## SERVICE BULLETIN

### NO. A3312-71-2

POWER PLANT - FAN COWL - HOLD OPEN ROD  
REPLACE DAMPER GUIDE ROD

FIGURE 1 - END CAP ASSEMBLY AND DAMPER

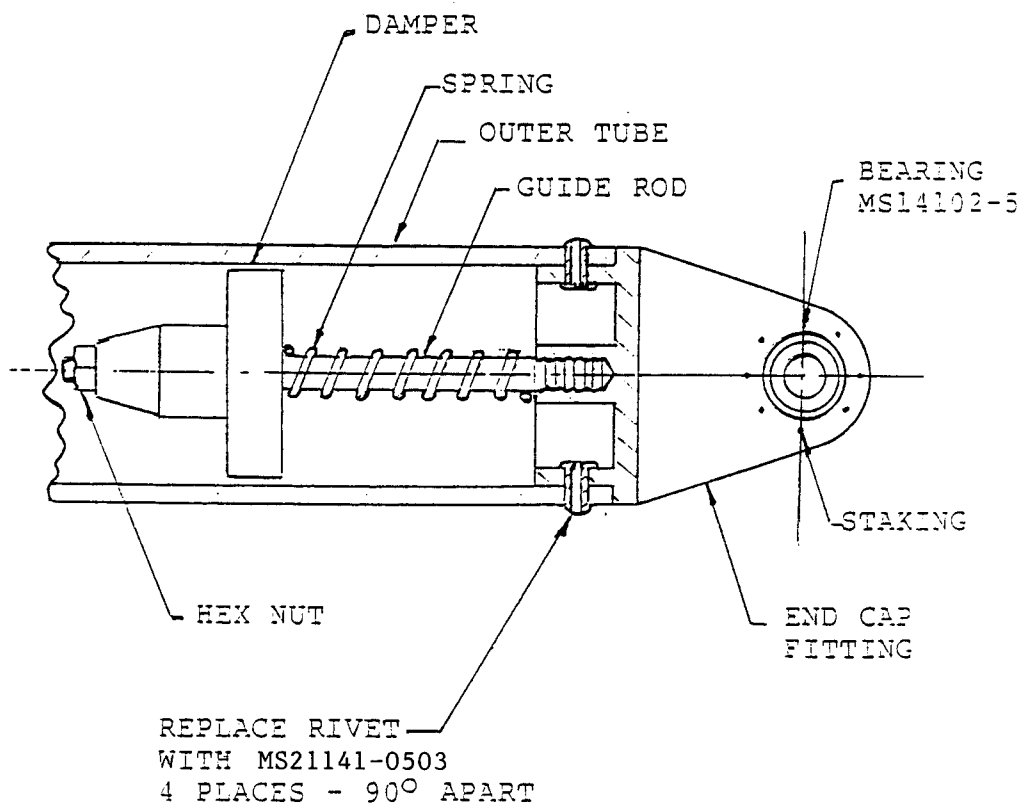
The incorporation of this Service Bulletin will prevent bending of the damper guide rod which has resulted in difficulty to fully retract the hold open rod.

This Service Bulletin provides detailed instructions required for all users to incorporate improved guide rod assembly in Norco P/N A3312-2, Rohr P/N 277D1250-503. This procedure consists of removing the four (4) rivets in the rear end of the outer tube and replacing the damper guide rod and end cap with new end cap assembly, AM3312-2-50. The reworked rod will be reidentified as Norco P/N A3312-3, and Rohr P/N 277D1250-505.

- C. Drill out four (4) rivets in outer tube, shown in Figure 1, using a No. 19 drill, .166 inch (4.216 mm) diameter. Center drill point in center of rivet. Drill only deep enough until rivet head separates from stem. Tap remaining rivet into outer tube.

- D. Remove end cap assembly from end of outer tube. Remove hex nut, damper, and spring from guide rod and save for use in new end cap assembly.
- E. Remove spherical bearing, MS14102-5, from end cap assembly by pressing out. Press bearing into new end cap assembly, AM3312-2-50, and stake at 8 points equally spaced around both sides of the bearing housing. The staking tool should have a spherical radius of .093 - .108 inches (2.362 - 2.743 mm) and produce a .010 - .015 inch (.254 - .381 mm) indentation located .050 - .060 inches (1.270 - 1.524 mm) from the O.D. of the bearing.

- F. Insert end cap assembly into end of outer tube and align rivet holes with pilot holes in end cap assembly. Drill out holes in end cap assembly using a No. 19 drill .166 inch (4.216 mm) diameter and holes in outer tube as pilot holes.

- J. Place end cap assembly back into end of outer tube and align rivet holes using marks placed on outer tube and end cap assembly.
- K. Apply primer TT-P-1757 and install four (4) MS21141-0503 rivets using a double action tool as indicated in Military Standard MS21141.
